**MONTGOMERY COUNTY PLANNING DEPARTMENT**  
 THE MARYLAND-NATIONAL CAPITAL PARK AND PLANNING COMMISSION

**Staff Report: 1050 Ripley Street**  
**Project Plan Amendment 92007004A**  
**Preliminary Plan 120080210**  
**Site Plan 820080150**

Amend the Project Plan to increase the number of multi-family dwelling units from 305 to 318 and the retail use area from 3,068 to 7,460 square feet. For the Preliminary and Site Plans, creation of one lot for the construction of 305,293 gross square feet of mixed-use development, including 297,833 square feet of multi-family residential uses with a maximum of 318 dwelling units including 48 MPDUs (15% of the total), and 7,460 square feet of retail uses, on 1.16 acres in the CBD-2 Zone; located in the southwest quadrant of the intersection of Ripley Street and Colonial Lane/Dixon Avenue, in the Silver Spring CBD Sector Plan.

Purple Line Potential Right-of-Way and Underground Garage Location

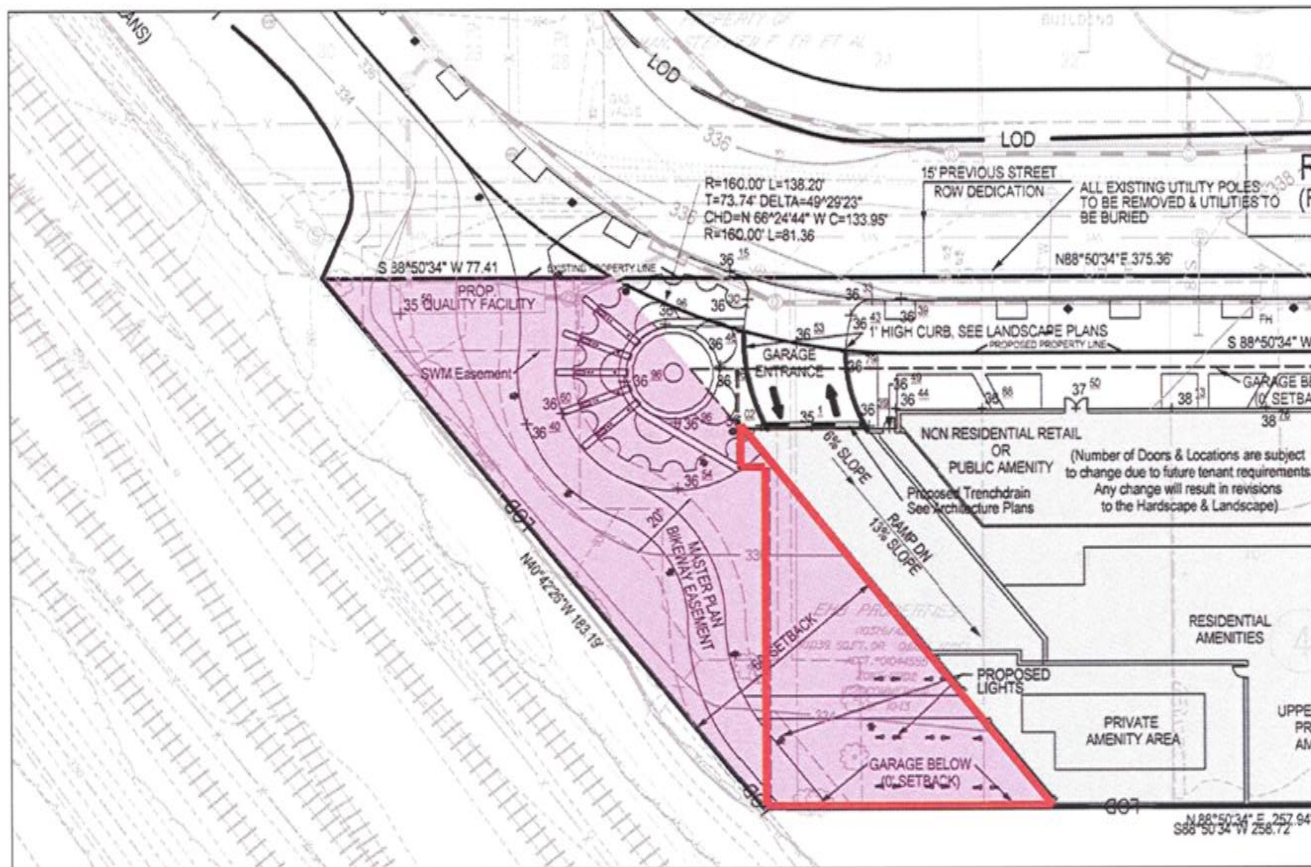
The Applicant is proposing underground parking within this corridor. MTA's current project planning as part of the Purple Line Draft Environmental Impact Statement/Alternatives Analysis (DEIS/AA) includes an alternative that would continue south of the applicant's parcel along the CSKX right of way and enter into a tunnel at a point within the right-of-way of Silver Spring Avenue, south and east of the applicant's parcel. MTA has confirmed acceptance of the parking garage within the 60-foot wide corridor, provided that the underground structures are designed to support the Purple Line and provide clearances necessary.

At time of Project Plan, staff recommended that the applicant provide a surface easement for the Purple Line within the 60-foot wide corridor east of the CSX tracks and west of the proposed building. While no easement is shown on the subdivision plan presented for approval, a condition of approval, requires the easement to be shown on the certified preliminary plan and record plat.

A-102

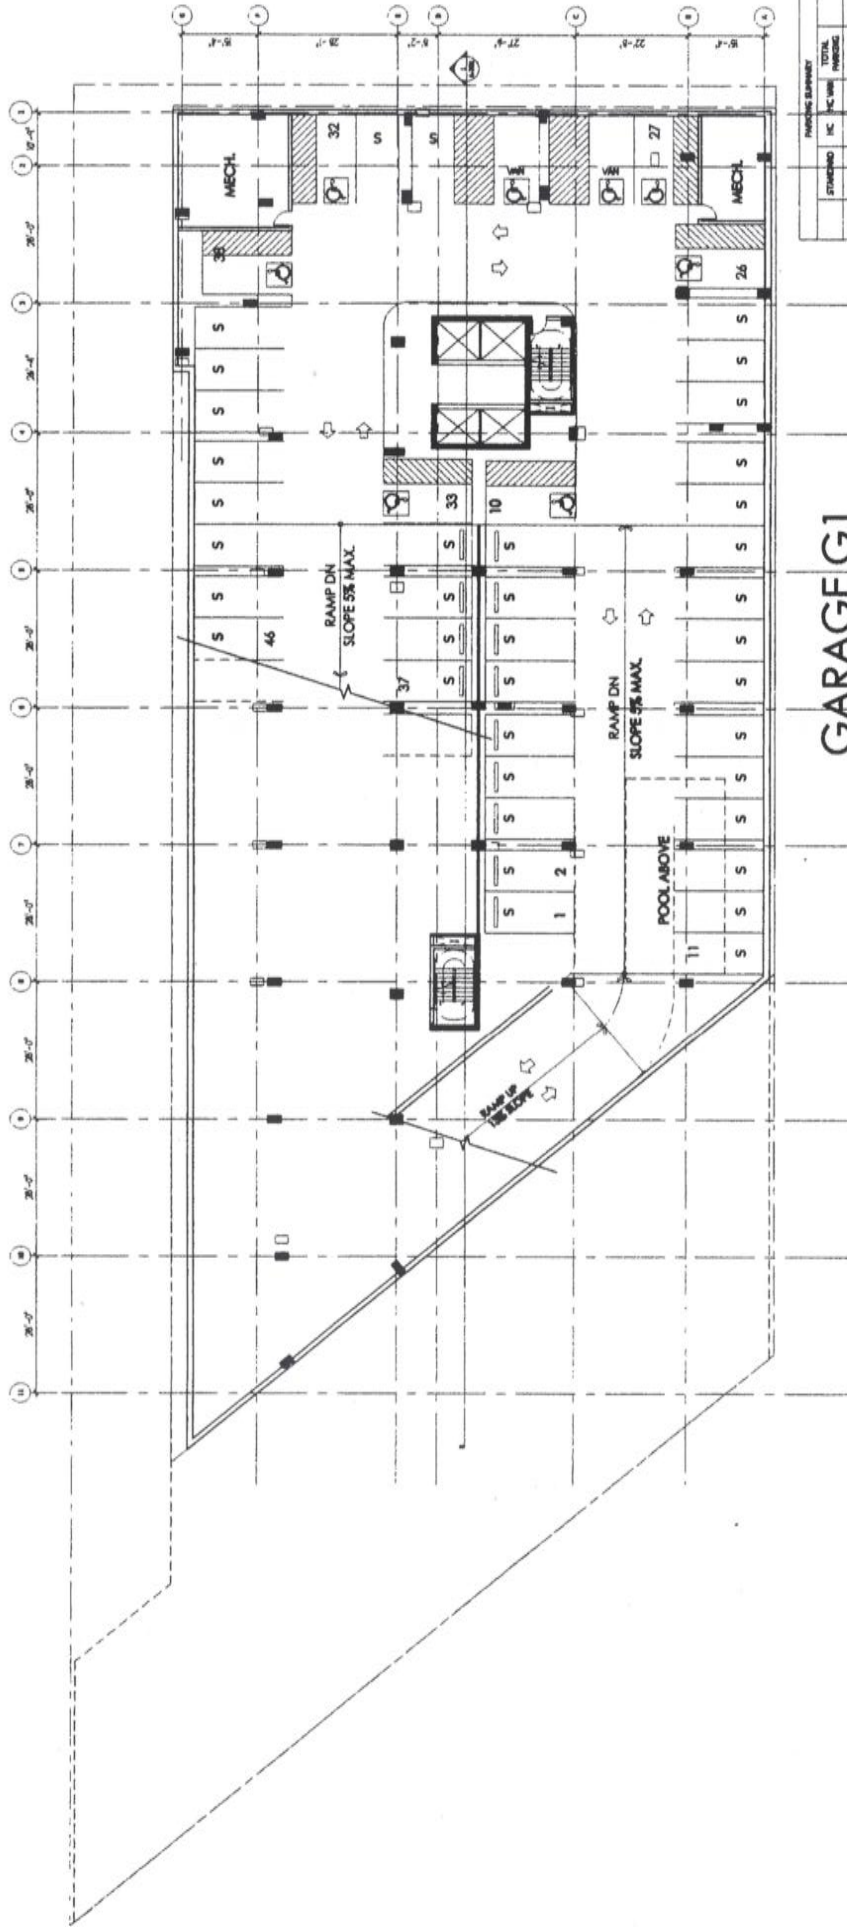
the garage, level G2 (Drawing A-102) depicts the portion of the garage roof that will have to be lowered 5' to 6' if the Silver Spring/ Thayer Tunnel option is selected.

DEPICT SECTION OF THE GARAGE ROOF THAT WOULD HAVE TO BE LOWERED 2 TO 6' TO PROVIDE THE CLEARANCE REQUIRED FOR THE PURPLE LINE TRANSITWAY OVER SPRING / WATER TUNNEL DESIGN OPTION.

8. Design and Construct necessary control joints and structural components in the southwest corner of the garage, level G2, to allow MTA to modify and lower the ceiling approximately 5' to 6' to provide the necessary grading and clearances for the proposed LRT or BRT infrastructure related to the Purple Line.
